FRANCHISE UTILITY-STREET/RIGHT OF WAY PERMIT

Permit # 11SCP 4613 <sup>REVISED</sup>  
Page 1 of 2

Location/Address: Evergreen Blvd from Daniels to Main St Applicant Job #: 12W2TEK

## ADDITIONAL CONSTRUCTION REQUIREMENTS

REVISED DRAWINGS 1 of 3

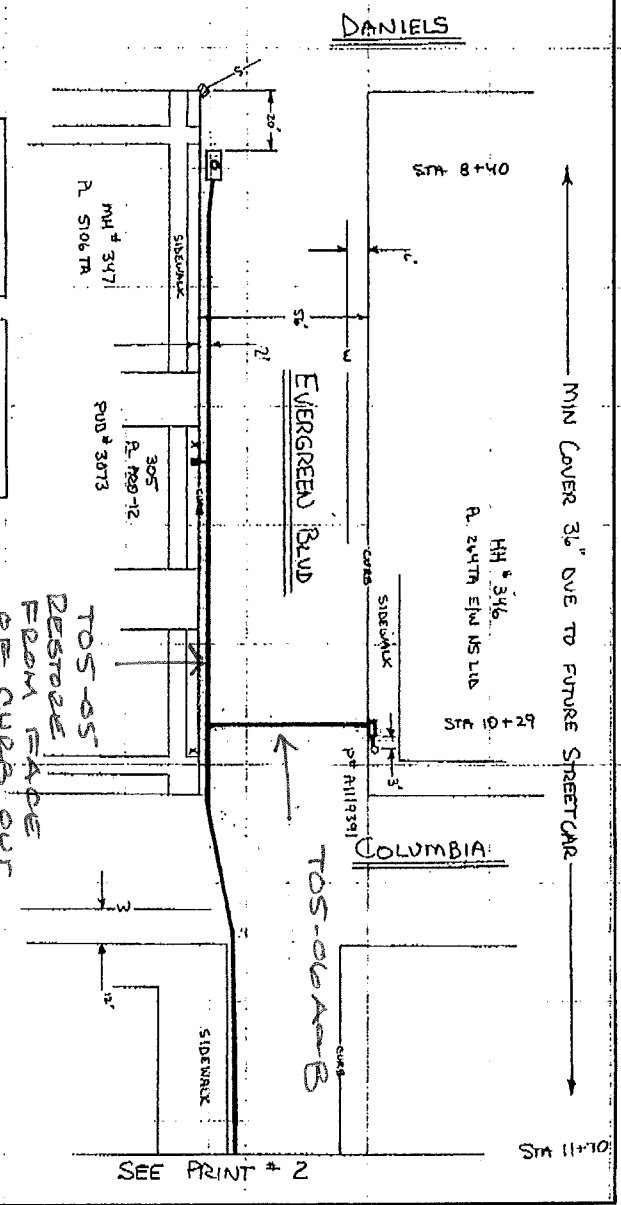
TOS-OS  
DESTROY  
FROM FACE  
OF CURB OUT  
4 FT.

REVISED  
DRAWING 2 of 3

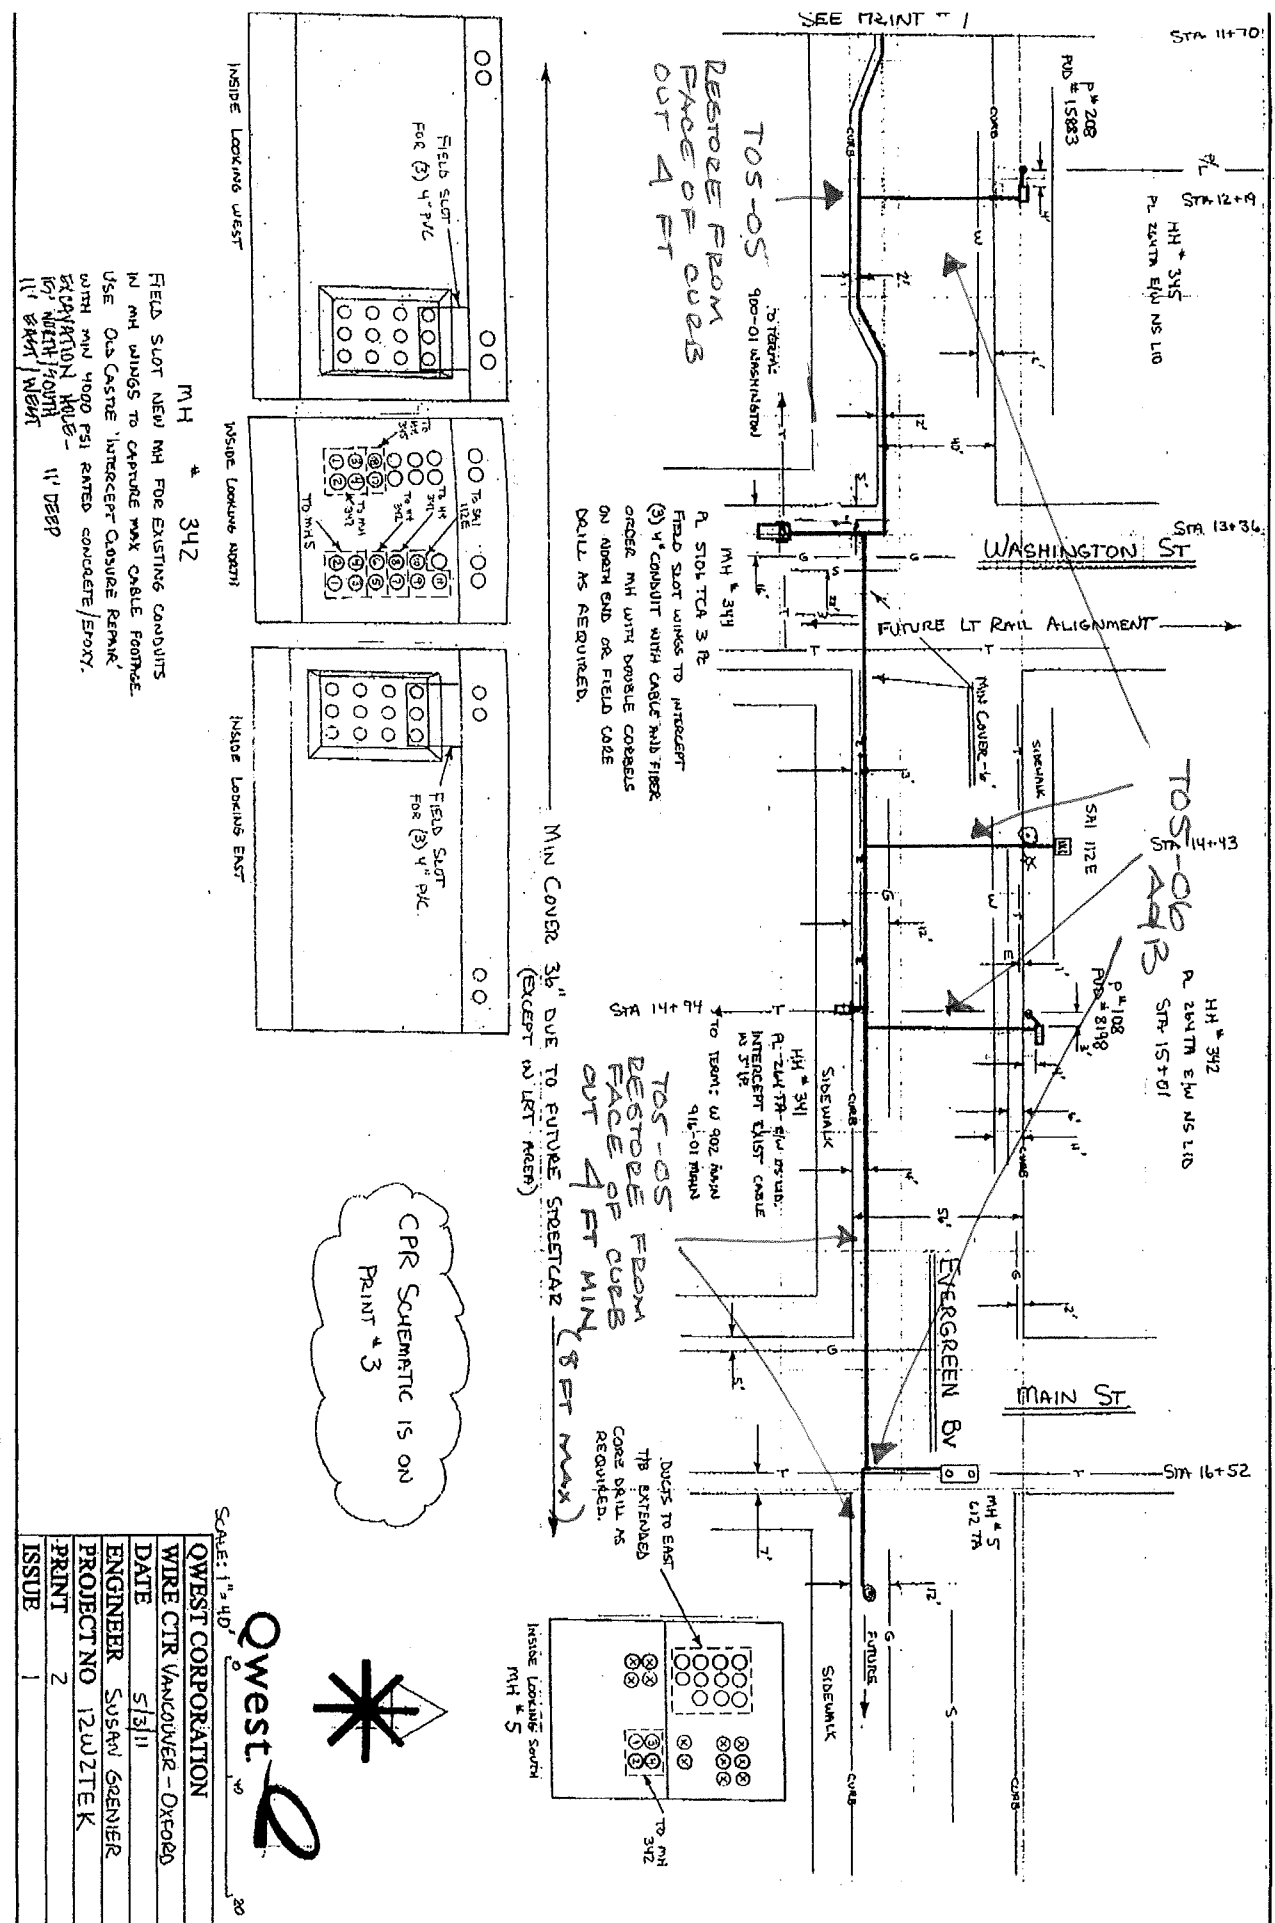
FIELD SLUT NEW MH FOR EXISTING CONDUITS IN MH WINGS TO CAPTURE MAX CABLE FOOTING. USE OLD CASTLE 'INTERCEPT CLAUSE REMARK' WITH MIN 4000 PSI RATED CONCRETE / EPOXY. EXCAVATION MADE FOR MOUNT POINT 11' DEEP 11' SKIN / WEIGHT

MIN COVER 36" DUE TO FUTURE SPECTACULAR (EXCEPT IN LEFT REAR)

TOS-OS FROM RESTORE FROM FACE OF CURB OUT 4 FT MIN (8 FT MAX)

REVISED DRAWINGS 3 of 3

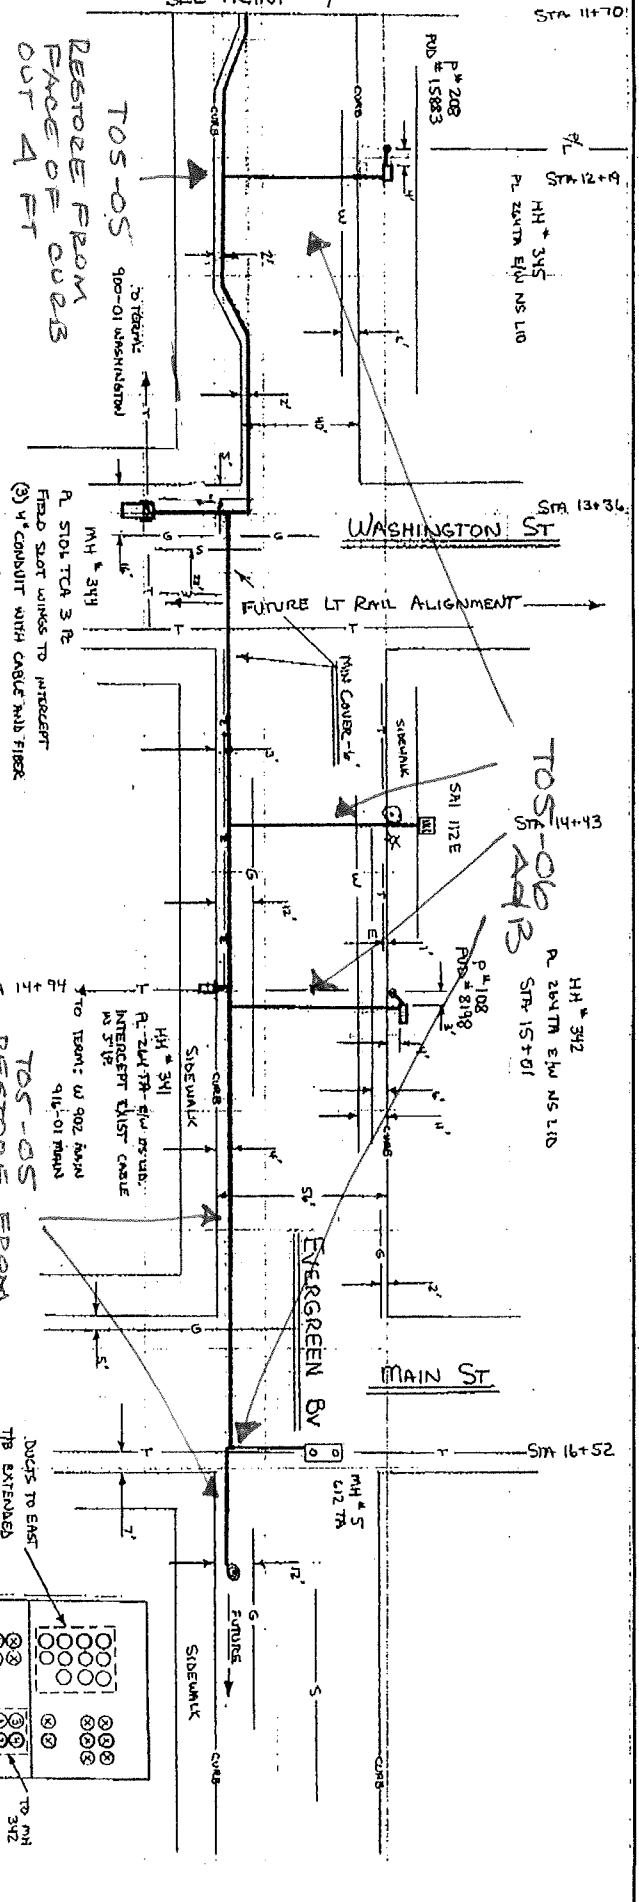
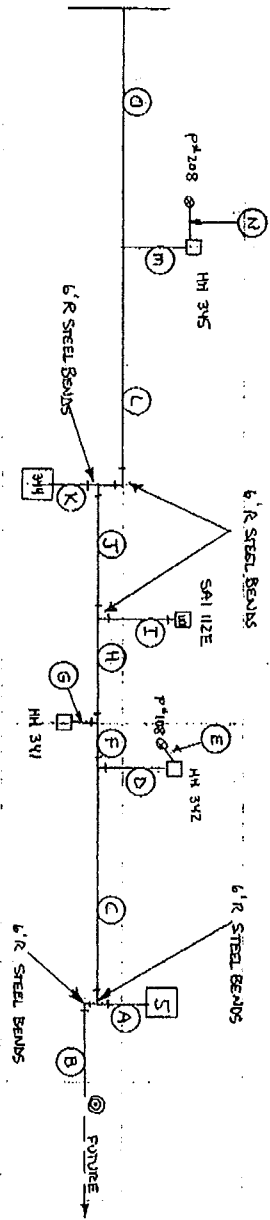
FIELD SLUT WINGS TO INTERCEPT (3) 4" CONDUIT WITH CABLE AND FIBER OPTIC MH WITH DOUBLE COVERS ON AHEAD END OF FIELD CASE. DRAIL AS REQUIRED.
